## **ZONING CHANGE REVIEW SHEET**

**CASE:** C814-2017-0001 – 425 W. Riverside PUD

**ADDRESS:** 425 W. Riverside Drive

**ZONING FROM:** CS-1-V-NP      **TO:** PUD-NP

425 WEST RIVERSIDE DRIVE  
AUSTIN, TRAVIS COUNTY, TEXAS  
EXHIBIT E - STREET CROSS-SECTIONS

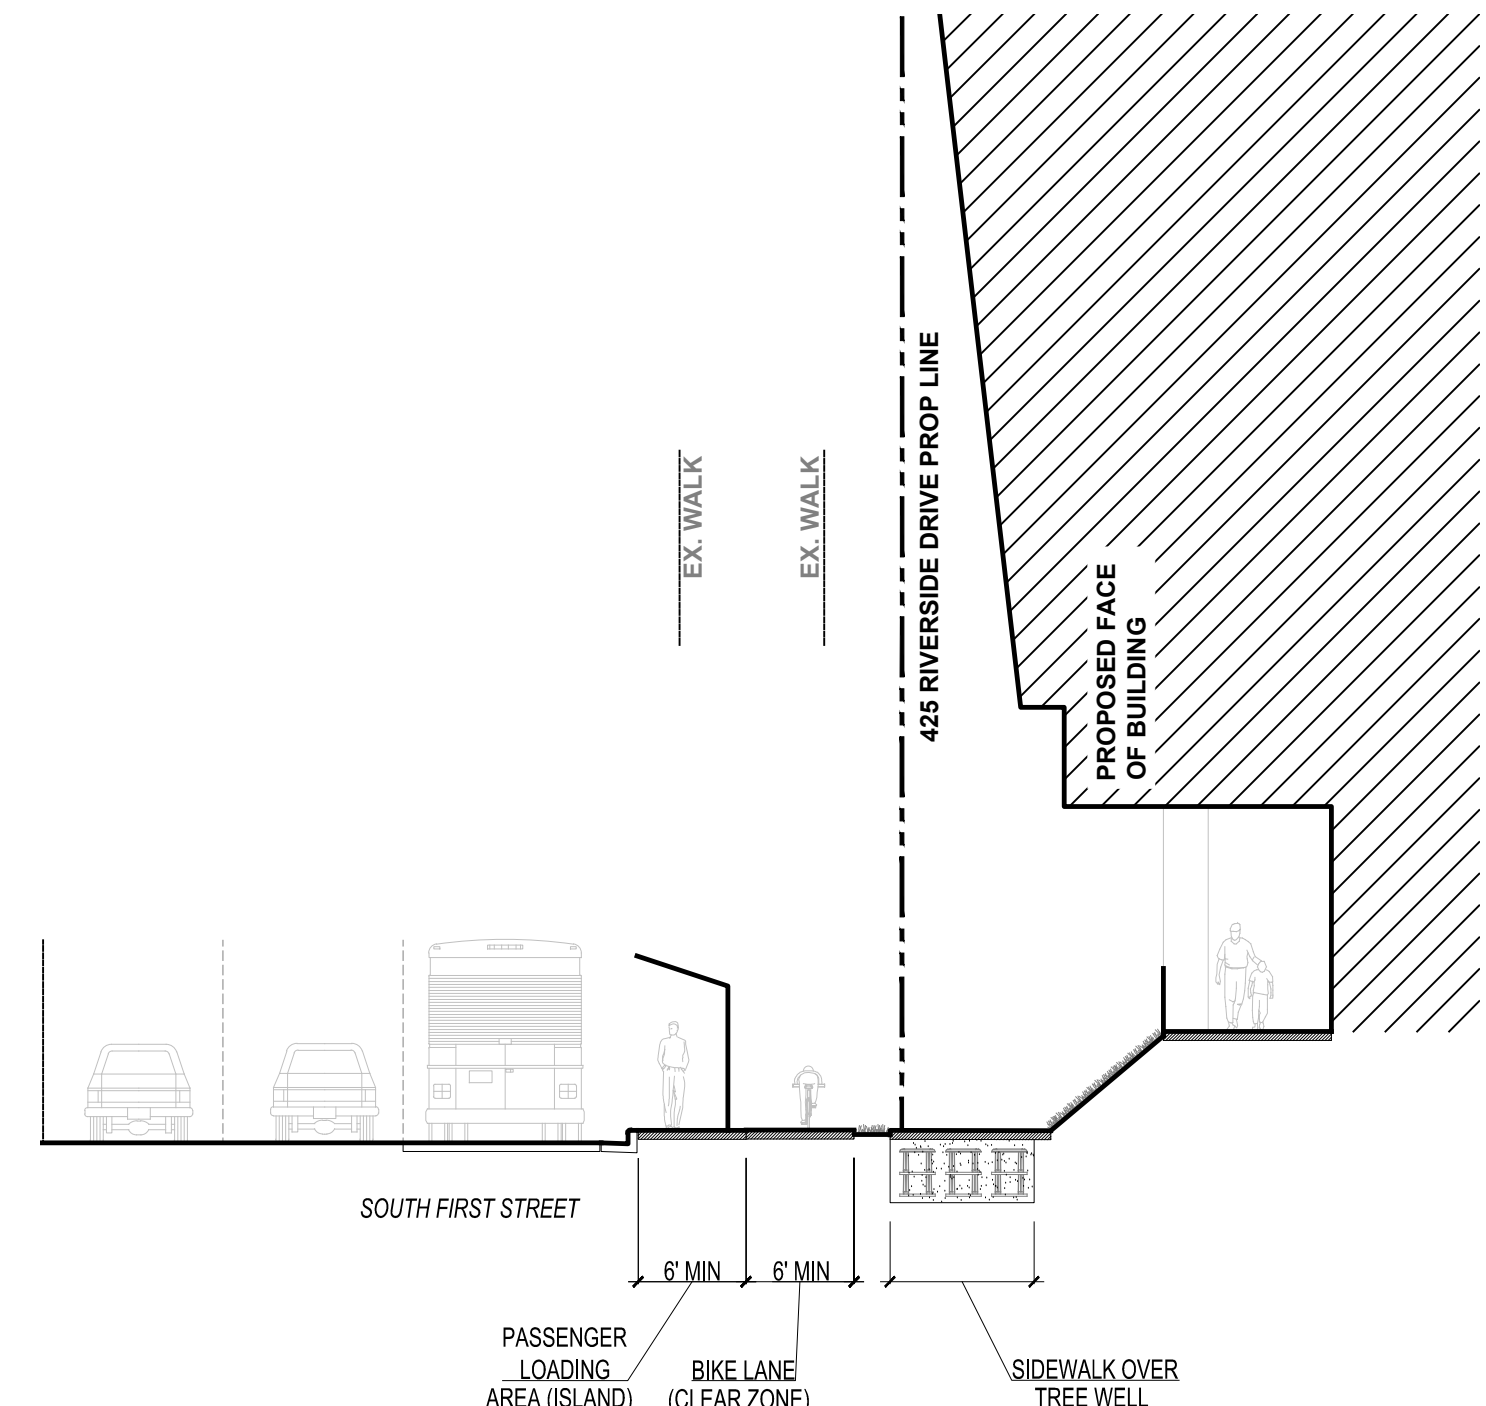
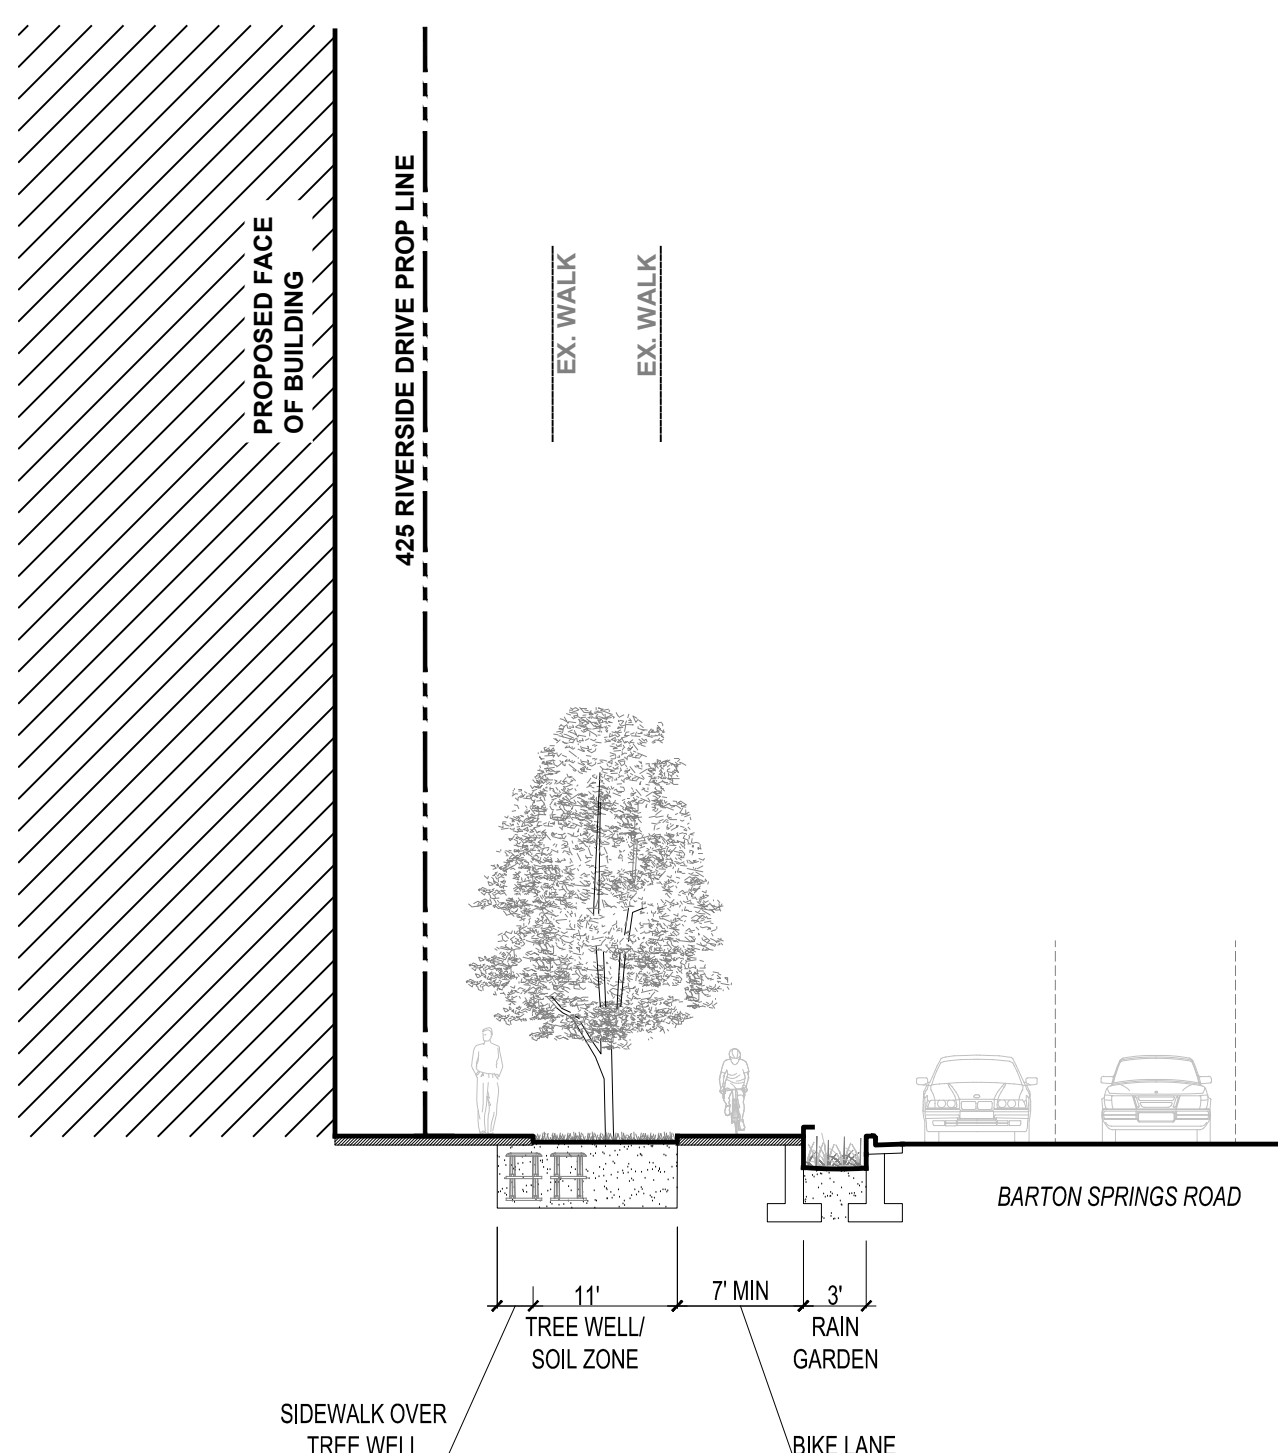
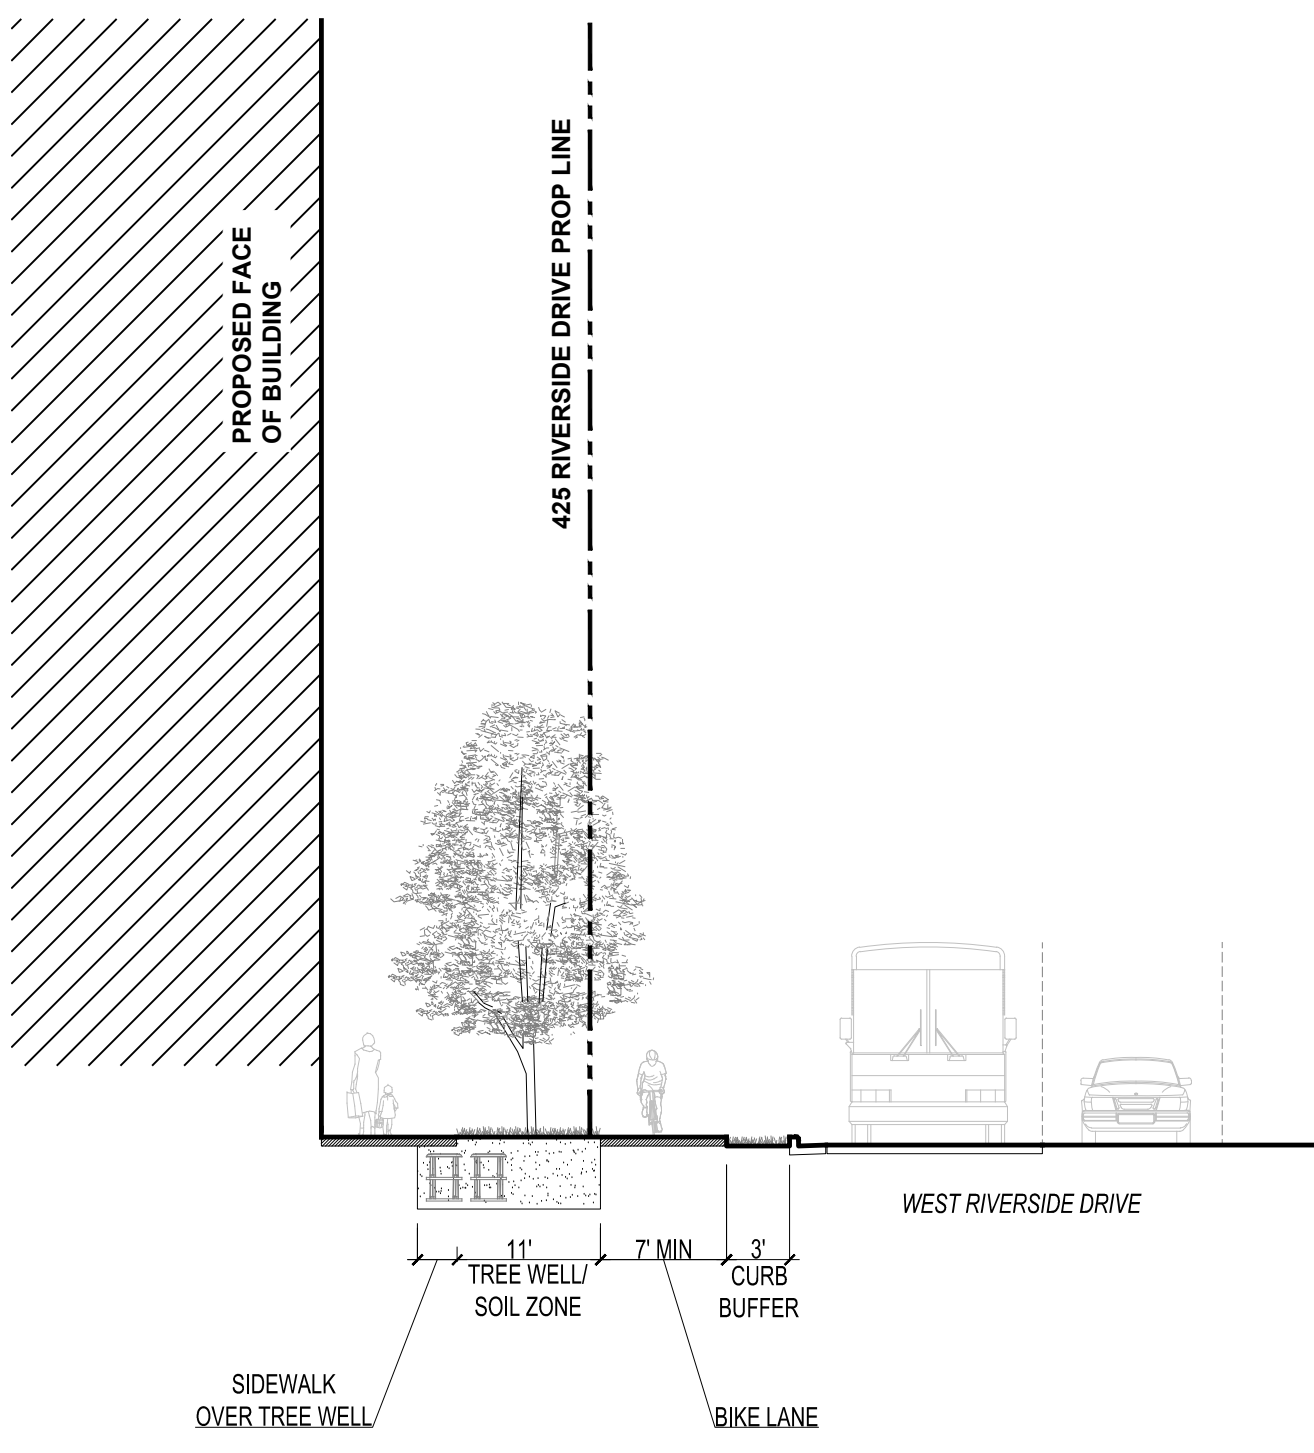
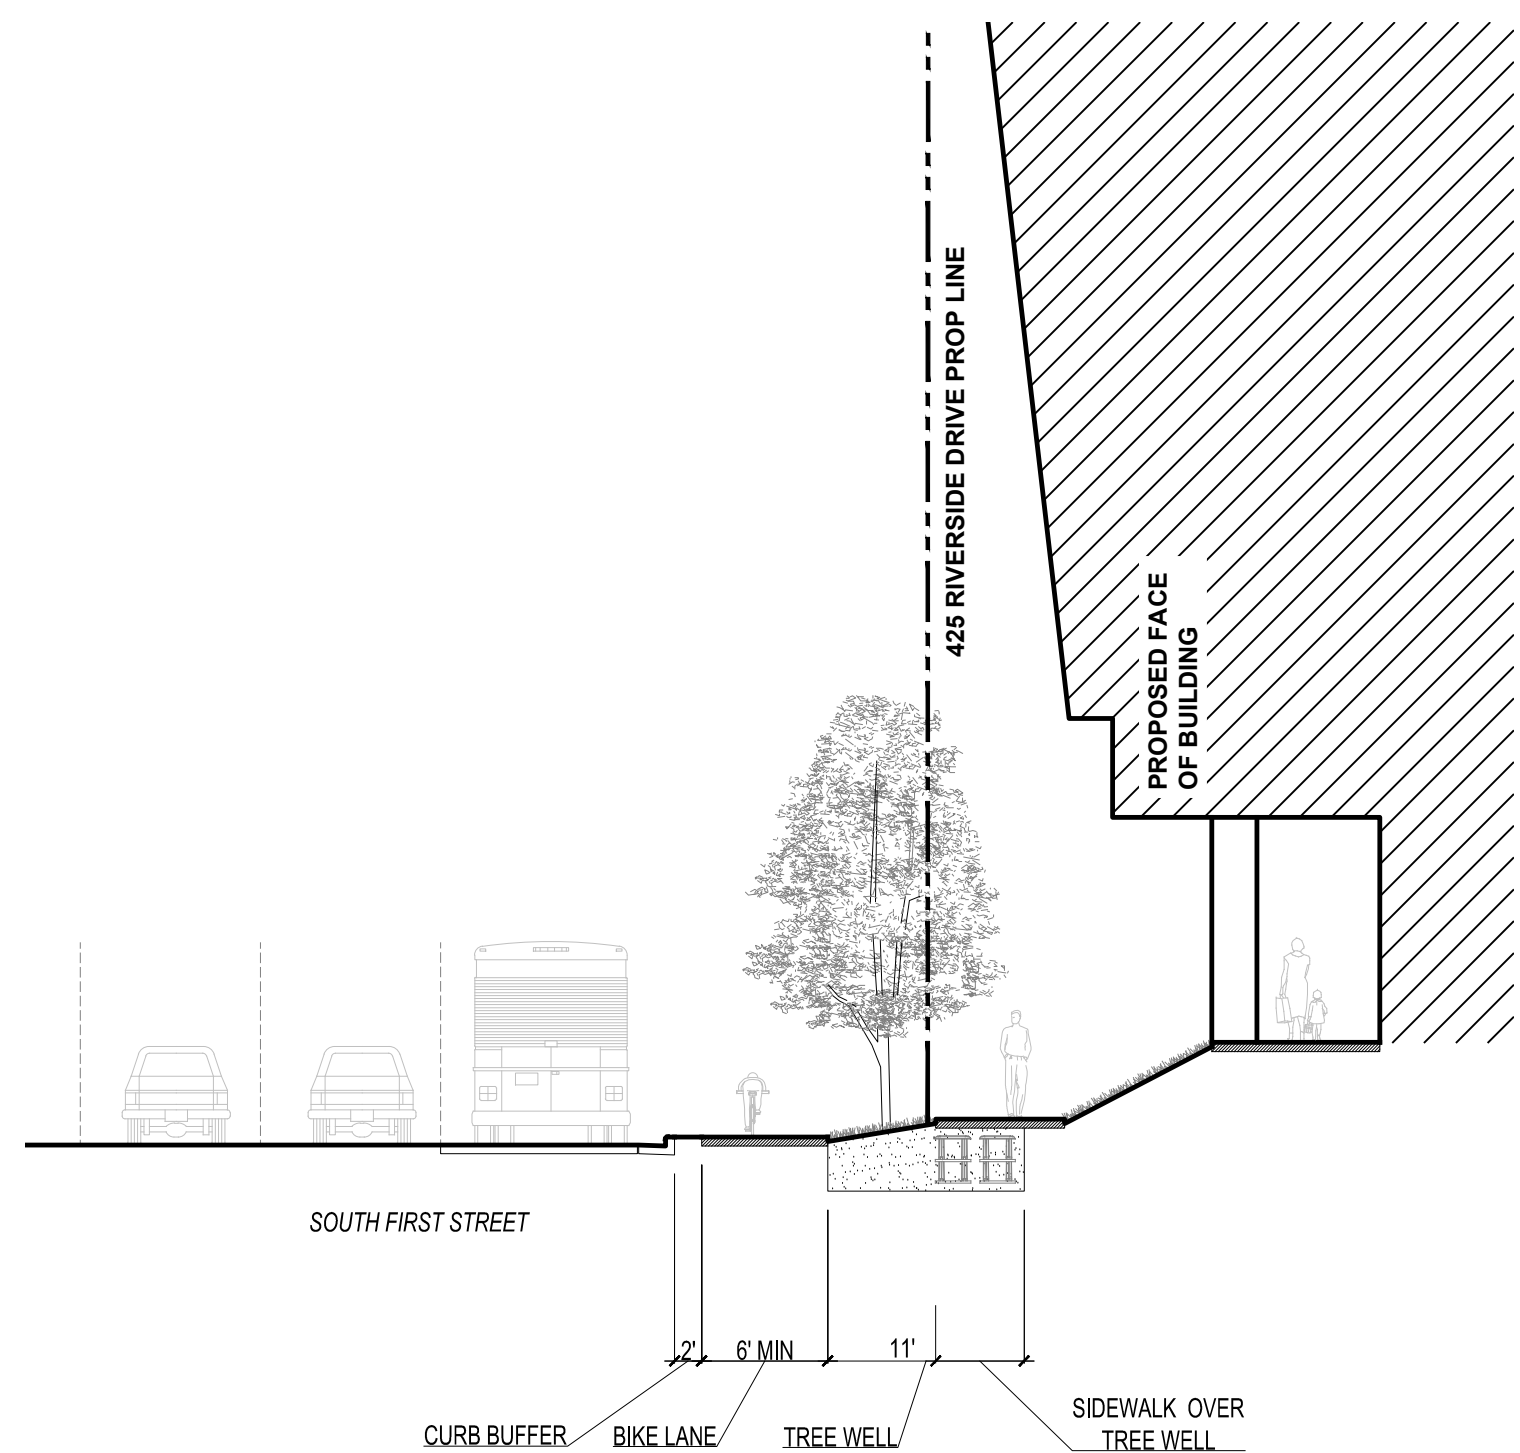
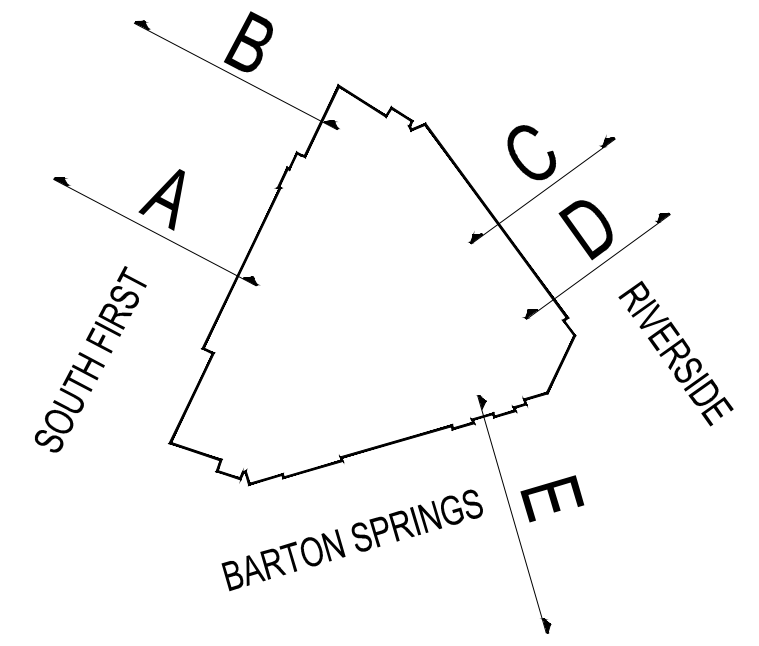
- #3 Bicycle Lane Width - the bicycle lane widths do not conform to the original drawing I sent in May. In the attached Exhibit C and E I have marked up width changes. In short the following are the dimensional requirements for the bicycle lane in a few scenarios:  
If pavement on either side of bicycle lane is not rideable than 7' is the minimum bikeway dimension.

If there is a dropoff into a rain garden there needs to be a hand rail that is recessed from the bike lane by 6" as to not encroach in the bicycle lane space (handrails should be added to relevant cross sections in exhibit E. If there is rideable pavement on both sides of the bike lane the minimum acceptable dimension is 6'
